Subject: Crystal River Unit 3 – License Amendment Request #307, Revision 0:
Methodology for Rod Ejection Accident Analysis Under Extended Power Uprate
Conditions – Response to Request for Additional Information

LICENSE AMENDMENT REQUEST #307, Revision 0

**Response to Request for Additional Information
(non-Proprietary)**

Figure RAI-03-1

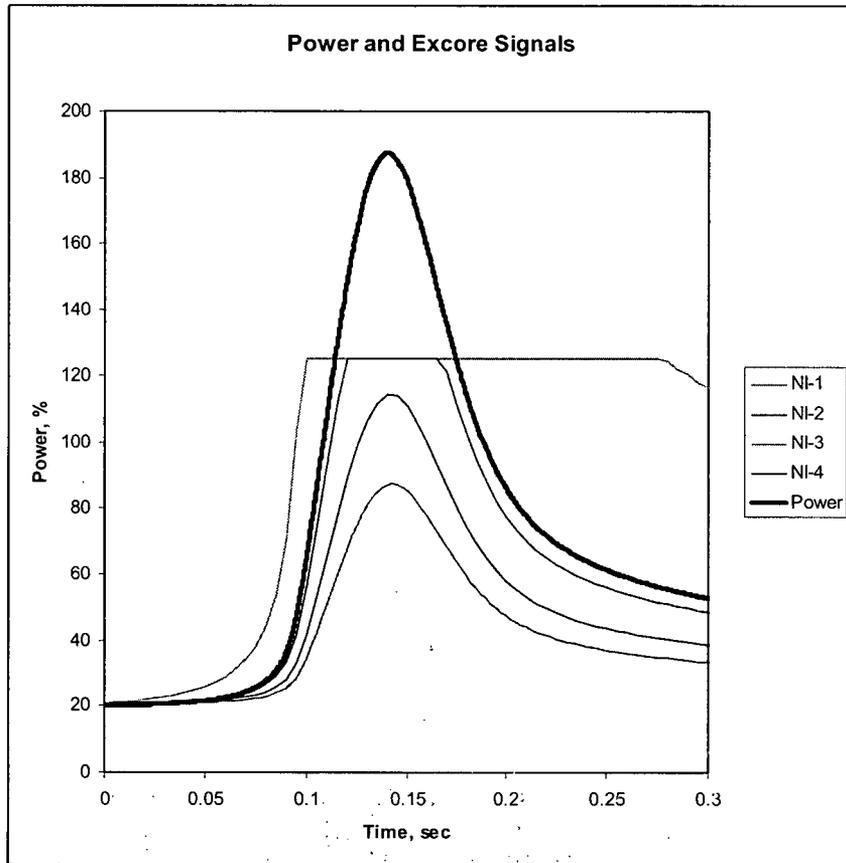
The 20% power EOC case analyzed in Chapter 8 has a power pulse peak of 187% (Table 8-6), which is beyond the 112% high flux trip point (Table 8-1). Why was this transient analyzed assuming no trip during the first 5s, but instead continued using the system code and terminated using one of the other trip signals?

The core power listed in Table 8-6 of ANP-2788P, Revision 0, is the core power and is not the indicated power of the excore detectors. The plant trip employs the indicated power from the measured signals of the excore detectors. The trip depends on the excore signal response to the ejected rod event. The excore signal response has two dependencies that are discussed in this response. First, the excore signal depends upon the proximity of the detector to the location of the ejected rod. Second, the maximum excore power signal from the circuitry is 125 percent power. Both of these dependencies can be modeled in NEMO-K. The End Of Cycle (EOC) ejected rod simulation from 20 percent power is shown in Figure RAI-03-1. As described in Table 8-1 of ANP-2788P, Revision 0, three analyzed signals must be above 112 percent power to trip the plant. In this figure, two of the signals reach the maximum indicated power. The third highest signal reaches approximately 114 percent power which would have tripped the plant. However, this value is close enough to the trip value of 112 percent, that minor variations in the major variables that control the peak power could result in lower powers and not trip the plant. For example, if the mean generation time (or inverse average thermal neutron velocity) was 3 percent higher, then the peak power would be approximately 3 percent lower and this plant transient would not have induced a reactor trip. Rather than fine tuning which conditions would not cause the trip, the analysis for the EOC 20 percent power case was conservatively run with no high flux trip.
